SYDNEY OLYMPIC PARK AUTHORITY

Planning Assessment Report

Application No:	DA 03-05-2021
Application Site:	SP101702, in 2 Figtree Drive, Sydney Olympic Park, NSW 2127
Proposal:	Fitout of ground floor retail tenancy as supermarket, liquor store and ancillary café; inclusive of façade amendments, window decal screens and business identification signage.
Applicant:	Architecture Design Studio NSW
Consent Authority:	Sydney Olympic Park Authority (SOPA)

Figure 3: Plan of the proposed internal layout of the supermarket (green), ancillary café (yellow) and Liquor Store (red) with back of house (blue)

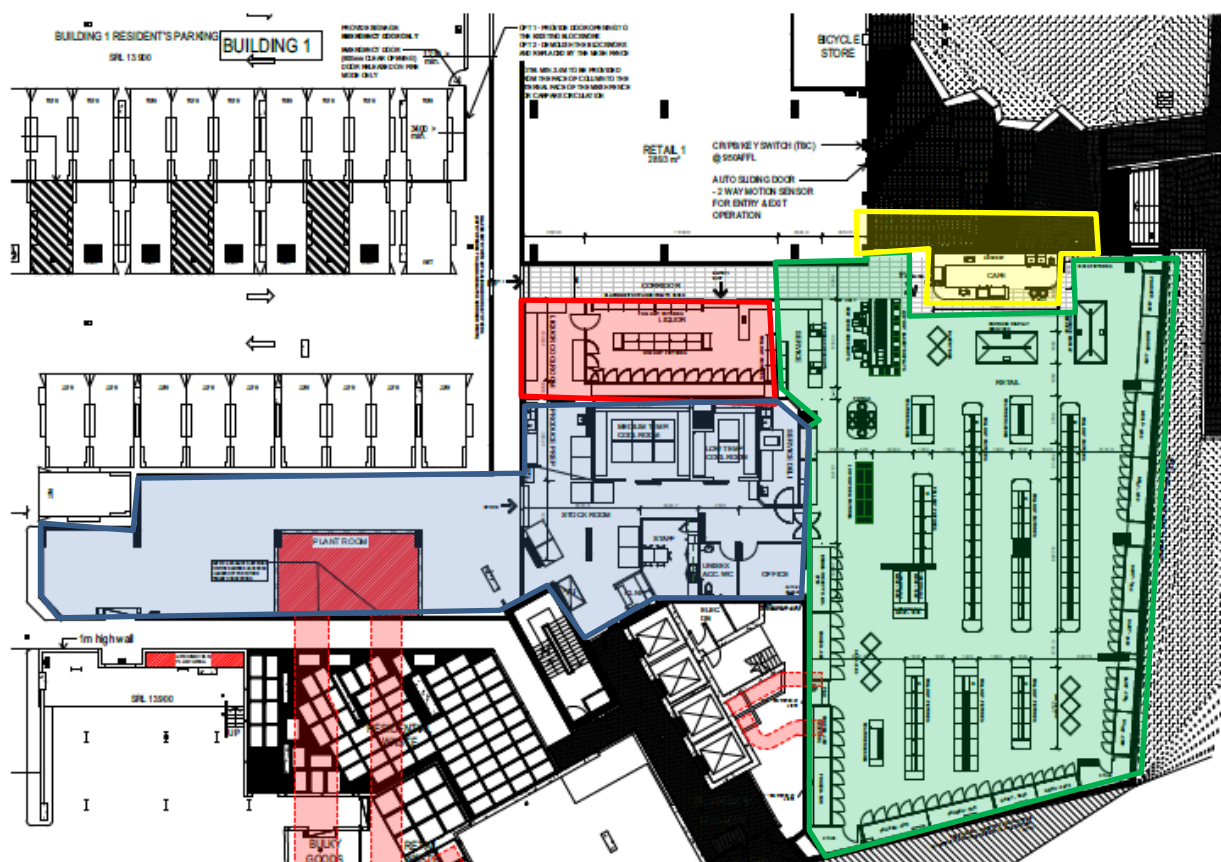
The supermarket will be divided into a number of zones, including the main retail floor area, liquor shop, café and back-of-house and cool room areas. All stock will be received via the loading dock within the building.

The café will be operated as part of the supermarket (not as a separate business or sub-lessee) and will be ancillary to the supermarket use. The café will be accessed by customers from both within the supermarket, or via a servery that will open onto the forecourt on the northern side of the supermarket and will offer coffee/tea, cakes, pre-made sandwiches and other assorted food and drink products. Other than the preparation of hot drinks and the warming of food products in microwave and/or warming ovens, no cooking or food preparation will be carried out within the café. The ancillary café will provide 4 tables and 12 chairs against the building façade. It is noted that this is located within the curtilage of the site and will not infringe on SOPA operational plan.

It is considered that the internal fitout of retail unit 2 will not impact on the design excellence of the site. However, given the operational requirements of the unit as a supermarket which include refrigerated and freezer units it is considered the most appropriate location for these units is along the rear and side wall of the floorplate – in front of the glazing. As such, the glazing would be obscured and visually unpleasant when viewed from the public domain. The applicant thus

proposes decal screening to the south and east windows of the unit with an approximate 600mm gap at the top to allow natural daylight to penetrate above the refrigeration and freezer units. SOPA has been consulted on the design of the decals screens and considers they provide visual interest to the façade. Overall it is considered that in this instance the principal purpose of the decals screens is not to provide advertising for the unit and further, the business identification signage on the decal screens is subservient to the overall design. Accordingly, on this basis, and taking into consideration the guidance contained within the SOPA Commercial Signage Policy, in this instance the decals screens are acceptable, subject to standard decal screen maintenance conditions.
